# NE 65th St Vision Zero 60% Design Review

Andres Salomon dilinger@queued.net

As of November 2017, the NE 65<sup>th</sup> Vision Zero Project is at 60% design. While the current design will be an improvement for people biking, there are a number of serious safety concerns for people walking and biking that remain unaddressed. We appreciate SDOT's willingness to make improvements to the corridor, and highly encourage SDOT to give more serious consideration to community concerns.

## 3) Left-turn pockets are needed for drivers turning left onto 25th Ave NE.

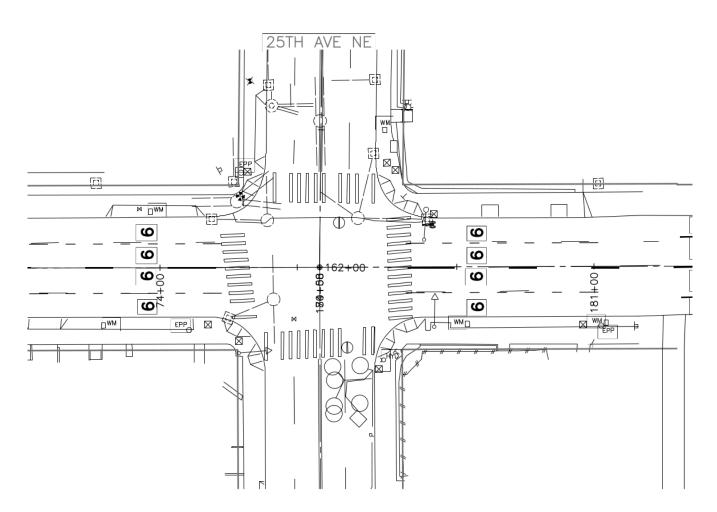
If left turn pockets are undesirable, then please consider curb bulbs to improve pedestrian safety, slow down turning drivers, and increase driver predictability.

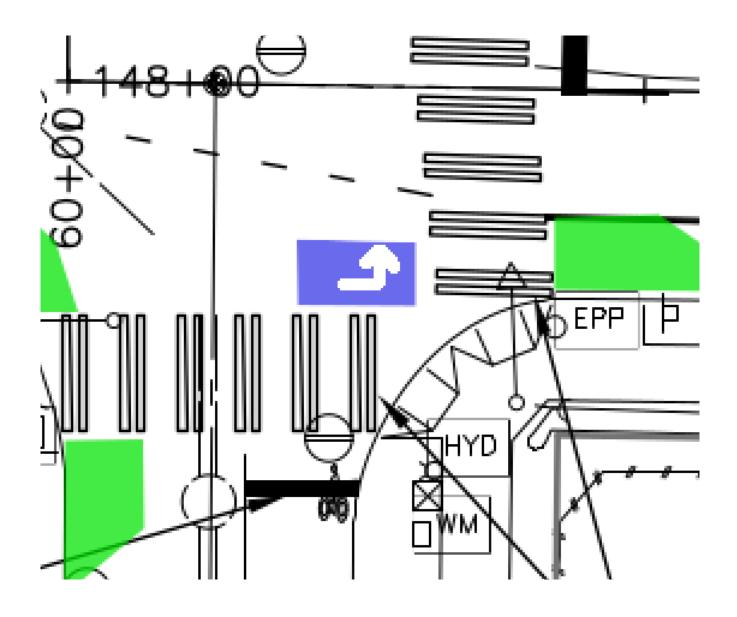
In addition, a pedestrian was killed at this intersection this year. The community made a recommendation to restrict right-on-red turns, and to add a curb bulb to help with compliance (as well as giving pedestrians more safe space).

There are numerous opportunities to improve safety here. I've illustrated example curb bulb locations in green below, and an upside-down "no right on red" sign to mark the needed right turn restriction. Please consider narrowing the crossing distances for pedestrians.

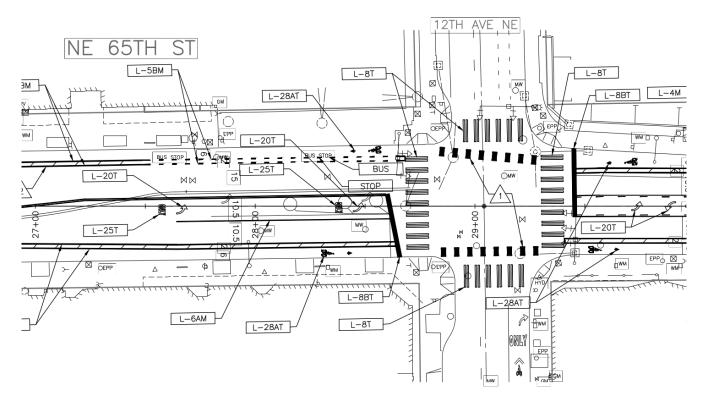
As an aside, the southeast curb bulb in this picture creates a safe space for eastbound cyclists to make a two-stage left turn onto 20<sup>th</sup> Ave NE. A potential enhancement (in purple) is below.

5) **The bus stop at 12<sup>th</sup> Ave NE should have a proper island** rather than conflicting with the bike lane, and the **left turn signal phase (onto 12<sup>th</sup>) should not overlap with oncoming traffic**.

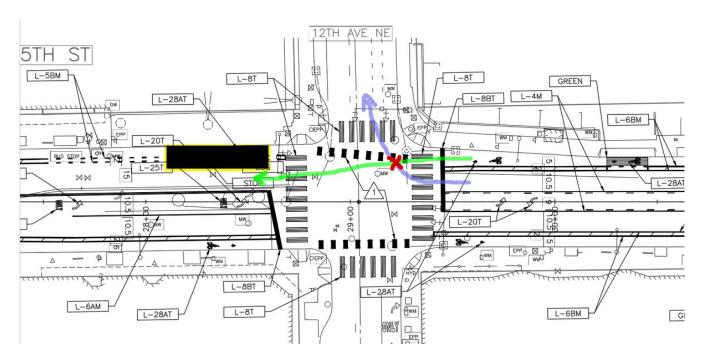
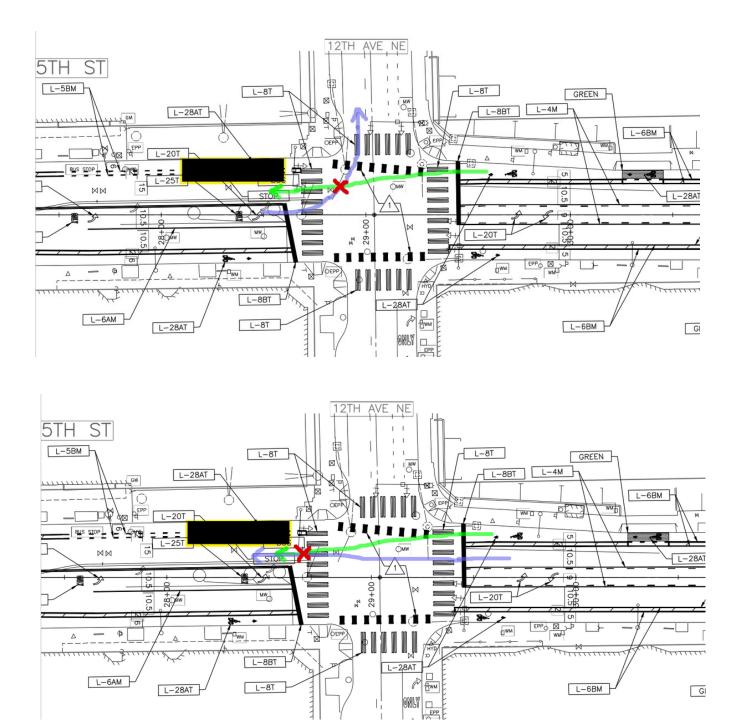
The current signal phase sequence at 12<sup>th</sup> Ave NE has an overlapping ("OLA") left turn phase (#6 in the above phase sequence), where the left turn arrow blinks yellow. I've seen this confuse left-turning drivers who think that they have the right of way (because they misunderstand what a blinking yellow turn arrow means – for example, <a href="https://www.youtube.com/watch?v=M-S64VaCOkY">https://www.youtube.com/watch?v=M-S64VaCOkY</a>). At the same time, the lack of bus island means there are three separate conflict risks for westbound cyclists; a left hook, a right hook, and being hit from behind while passing a stopped bus.

Removing the overlapping left turn phase will eliminate the left-hook risk. Creating a proper bus island will eliminate the risk of getting hit from behind (or getting hit by a bus pulling in or out of the stop).

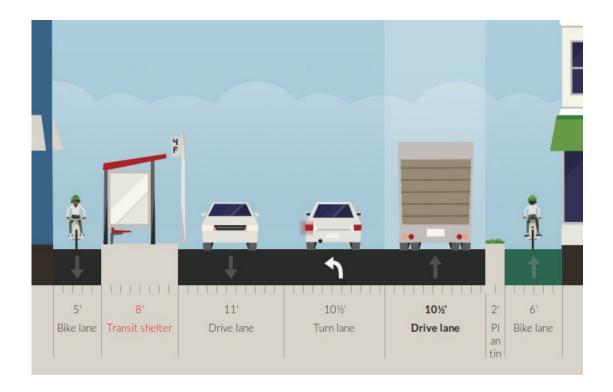
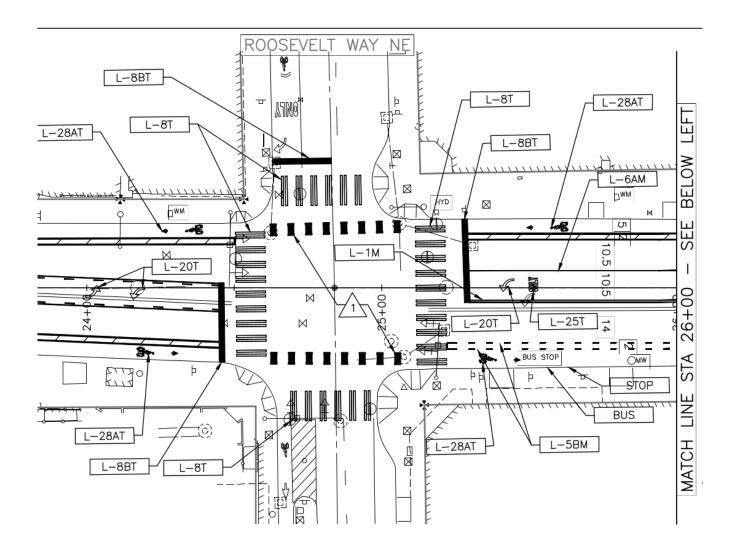
There appears to be enough space for that, given the proposed westbound 15 foot lane, 2 foot buffer, and 6 foot bike lane.

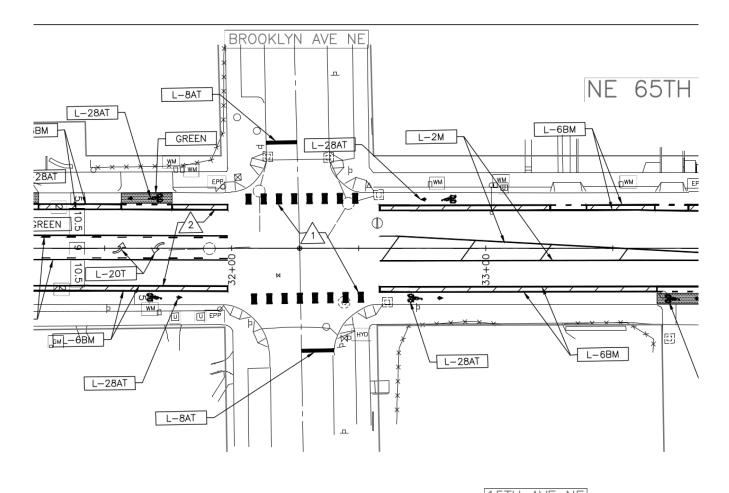
6) The same bus stop issue that exists above is also a problem at Roosevelt & NE 65th.

Two pedestrians have been killed here in the past few years; one by a driver turning east onto 65<sup>th</sup> from Roosevelt. SDOT responded by putting flex posts to hopefully slow down turning drivers. However, with this 60% design left-turning drivers will not only have to watch out for crossing pedestrians, they'll also have to watch for cyclists who are going around a stopped bus. **This intersection needs to have a proper bus island.** The bus island will have the beneficial effect of narrowing the roadway and slowing down turning drivers. With the opening of the light rail and additional traffic, this is especially crucial. **There also should not be a blinking yellow turn signal/overlapping signal phase.**

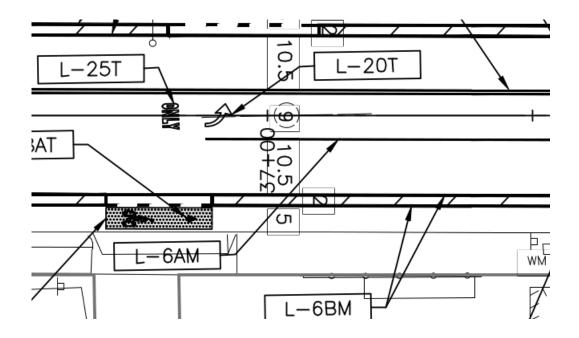
8) Intersections with one-way streets, such as Roosevelt & NE 65<sup>th</sup>, provide another opportunity for pedestrian refuge islands. In this case, the west side of the intersection is not used for turning. An example pedestrian island is in green below. A mountable curb apron for larger trucks might be appropriate in this location, but any kind of island would be a huge improvement.
